FSN 86600037A

**URGENT - Field Safety Notice
Medical Device Correction
V60 VENTILATORS MANUFACTURED BEFORE 15 SEPTEMBER 2015
INTERNAL CABLE REPLACEMENT**

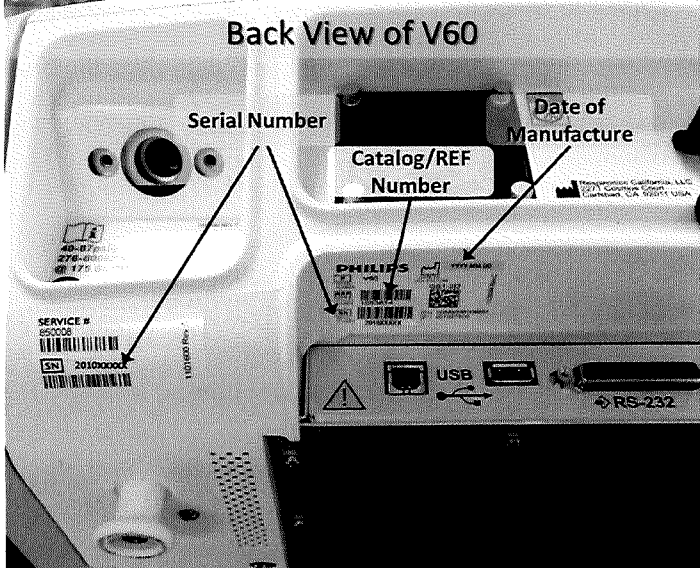
The date of manufacture is visible on the back of the V60 ventilators, so it is unnecessary to pause or discontinue the use of the ventilator to check it.

Please refer to the instructions attached to this letter to determine the date of manufacture of your V60 ventilators.
